FIELD CHANGE ORDER	NUMBER: DSRZA-I001
--------------------	--------------------

FCO DSRZA-I001

This FCO requires changing two PROMs in the DSRZA-BA/BB on the 54-16341-01 module and adding a revision tag to the unit.

FIGURE 1

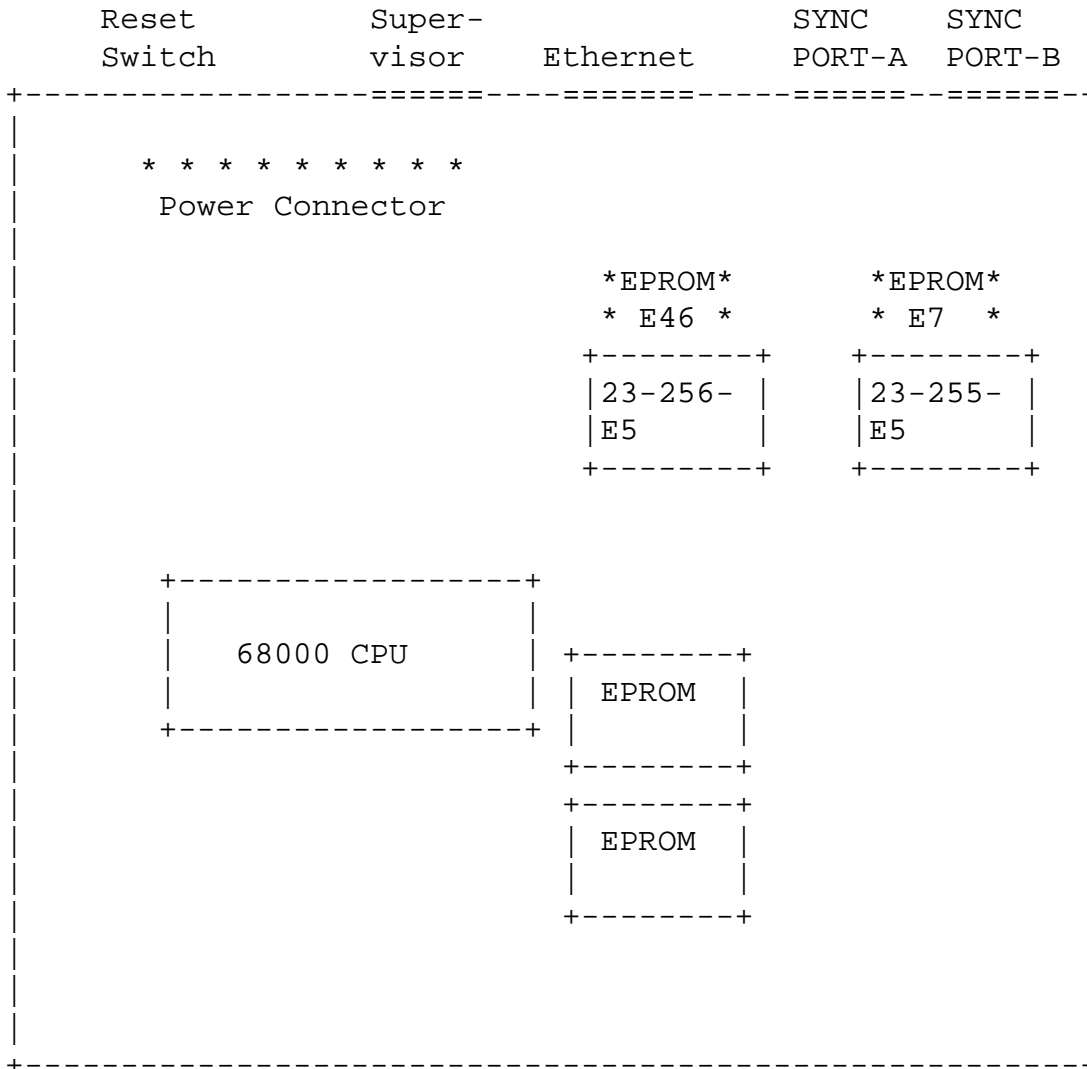
Find IC location E7 on the Muxserver layout diagram, locate old PROM on the module and remove that PROM (23-255E5-00). Carefully insert the new PROM "23-320E5-00" into IC location E7.

7. Locate the new PROM which has "23-321E5-00" printed on it. Find IC location E46 on the Muxserver layout diagram, locate old PROM on the module and remove that PROM (23-256E5-00). Carefully insert the new PROM "23-321E5-00" into IC location E46.

REPLACE EPROMS :
 E7 : 23-225E5-00 with 23-320E5-00
 E46: 23-256E5-00 with 23-321E5-00

NOTE: Depending on Rev/Vintage of MUXserver, E numbers and original PROM numbers may not agree with table.

FIGURE 2

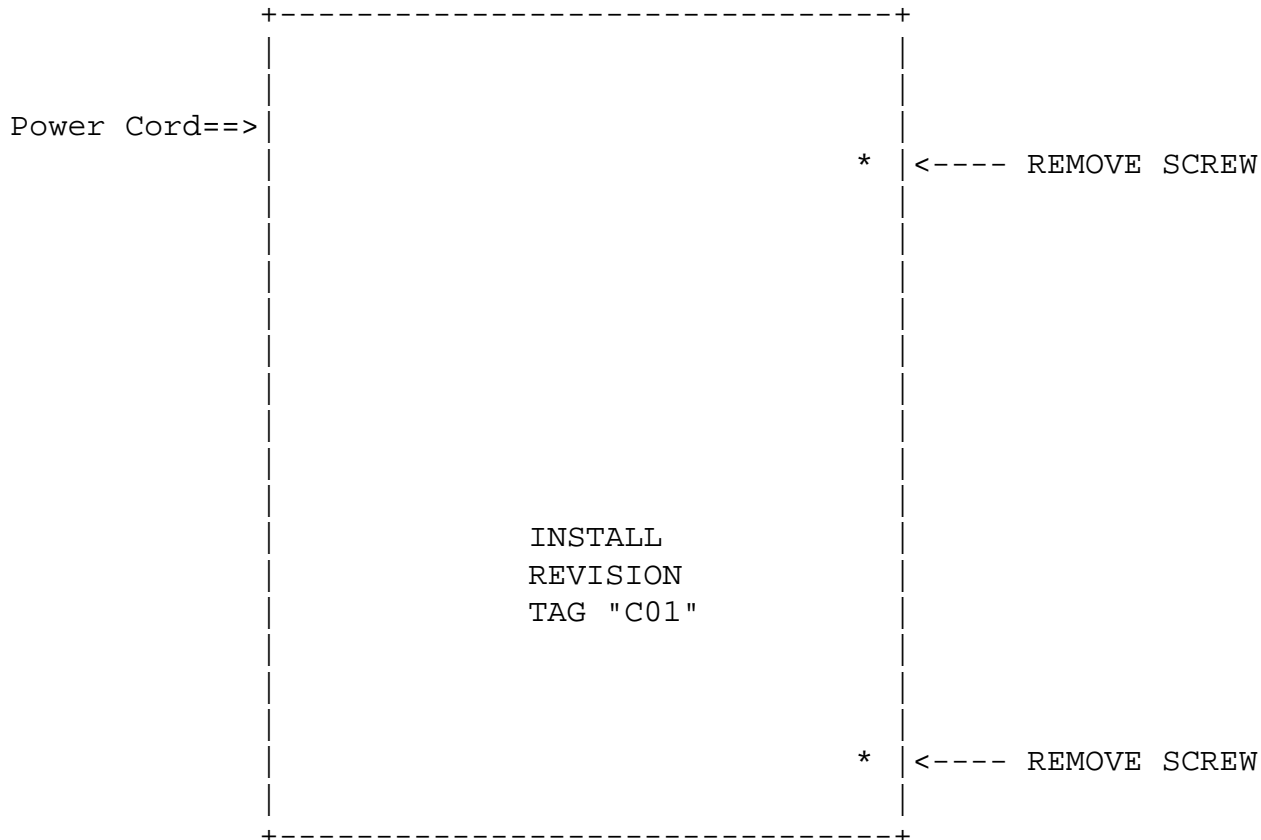
9. Take the revision tag that is included in the EQ kit, part no. 36-291631-03, and cut off the section that states "REV C01" and install it as shown in figure 2. The Muxserver firmware update is now complete.

NOTE: 1. Remove the two screws as indicated.

NOTE: 2. Install the revision tag where indicated.
